60- and 66-MHz Pentium® Processor Specification Update

Release Date: February 1997

Order Number 243326-001

21. Power-Up BIST Failure

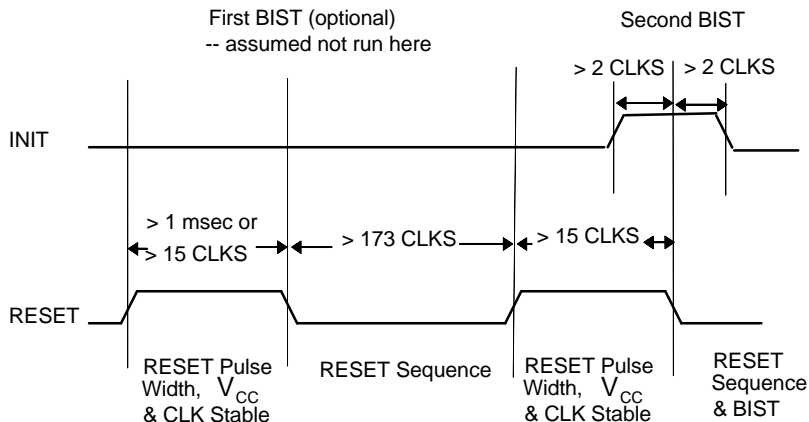
PROBLEM: The BIST (Built In Self Test) feature may fail.

IMPLICATION: Upon completion of BIST, a false failure may be reported. That is, a non-zero value may be returned in the EAX register, even though the part is operating correctly. As such, this erratum has no other product or system implications and is fully functional. To date, all observed false failures have returned a value of 20000H in EAX.

1. Invoke a double RESET — All false BIST failures have occurred during cold RESET. In order to accurately execute BIST, a double RESET sequence may be performed as shown in the figure below:

2. Use RUNBIST — BIST may be run through the RUNBIST instruction, available through the Test Access Port as documented. In this fashion, BIST will return correct values.

48. Asserting TRST# Pin or Issuing JTAG Instructions Does not Exit TAP Hi-Z State

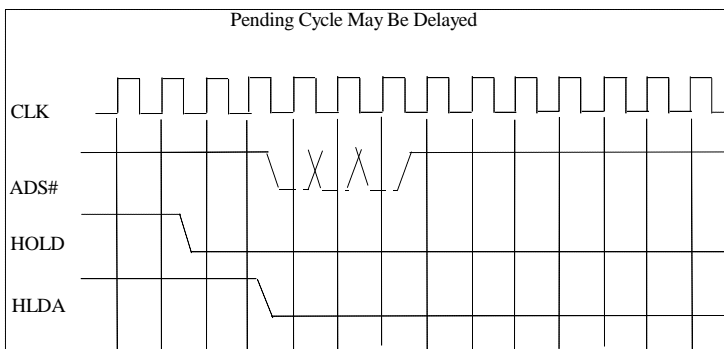
PROBLEM: The *Pentium® Processor Family Developer's Manual*, Volume 1 states that the TAP Hi-Z state can be terminated by resetting the TAP with the TRST# pin, by issuing another TAP instruction, or by entering the Test_Logic_Reset state. However, the indication that the processor has entered the TAP Hi-Z state is maintained until the next RESET. Therefore by using the above methods alone, the TAP Hi-Z state can not be terminated.

IMPLICATION: When the TAP Hi-Z instruction is enabled and executed, using the methods described in the *Pentium® Processor Family Developer's Manual*, Volume 1 may not terminate the Hi-Z state.

WORKAROUND: To exit TAP Hi-Z state, in addition to the methods described above, the processor needs to be RESET as well.

49. ADS# May Be Delayed After HLDA Deassertion

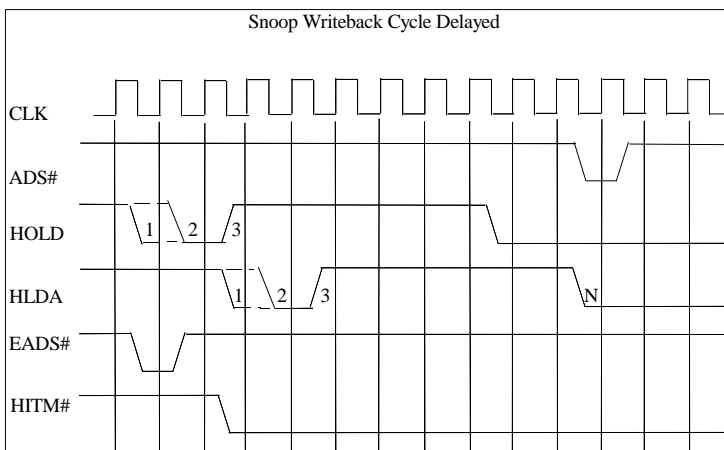
PROBLEM: The Pentium processor typically starts a pending bus cycle on the same clock that HLDA is deasserted. However, it may be delayed by as many as two clocks. See the diagram below.

In two cases, for example, if HOLD is deasserted for one clock (i.e., clock 2) or two clocks (i.e., clocks 1 & 2) and then reasserted, the window may not be large enough to start a pending snoop writeback cycle. The writeback cycle may be delayed until the HLDA is deasserted again (i.e., clock N). See diagram below.

IMPLICATION: If the system expects a cycle, for example a writeback cycle, and depends on this cycle to commence within the HLDA deassertion window, then the system may not complete the handshake and cause a hang.

1. Deassert HOLD for at least 3 clocks (i.e., clocks 1, 2, and 3 shown in figure) before reasserting HOLD again. This ensures that the Pentium processor initiates any pending cycles before reasserting HLDA.
2. If the system is waiting for the snoop writeback cycle to commence, for instance if HITM# is asserted, the system should wait for the ADS# before reasserting HOLD.
